SERVICE BULLETIN

No. 582

Piper Aircraft Corporation

Subject: Pitot and Static Sump Drain Inspection

Ref: S.B. #582

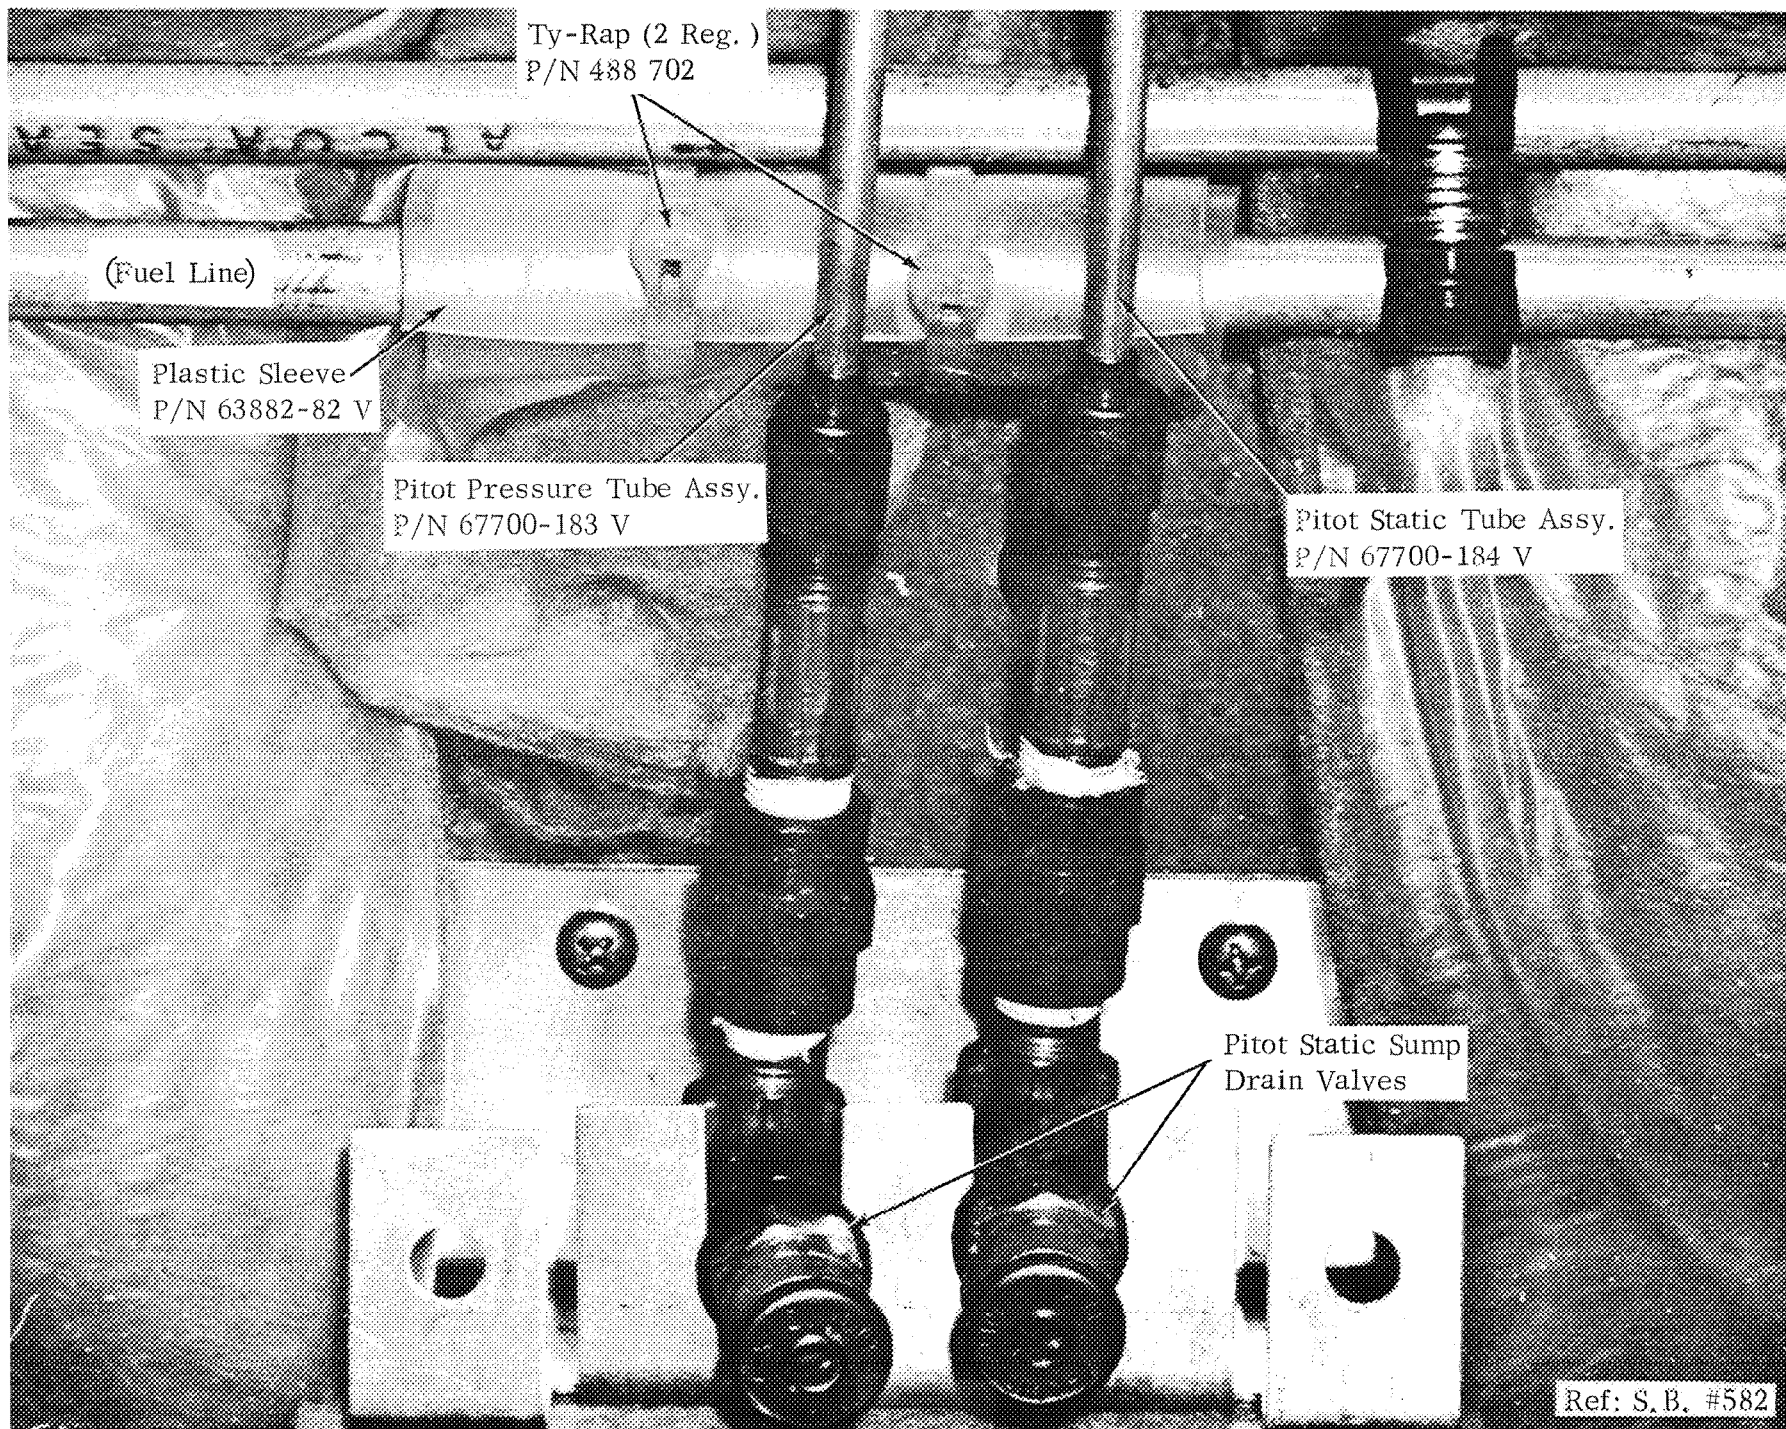
Purpose: The pitot and static sump drain was relocated on the seventy-eight year model aircraft. The possibility now exists that the lines going to these sump drains could possibly chafe on the nuts of a fuel line union running behind the sump drains.

1. Remove the upholstered side panel from the left hand side of the fuselage.
2. Inspect the two (2) lines connected to the pitot and static sump drain valves for any sign of chafing on the nuts of the fuel line union.
3. If any chafing is found then the line(s) must be replaced. Refer to Material Required for tubing part numbers.
4. If no chafing is found then install the plastic sleeve over the fuel line union as shown in the attached sketch.
5. Replace the side panel.
6. Make the appropriate log book entry that this Service Bulletin has been complied with.

Material Required: One (1) plastic sleeve Piper Part No. 63882-82V, two (2) ty-raps Piper part number 488 702V (MS3367-1-9). If required by instruction number three (3), one (1) 67700-183V and one (1) 67700-184V, Tubes.
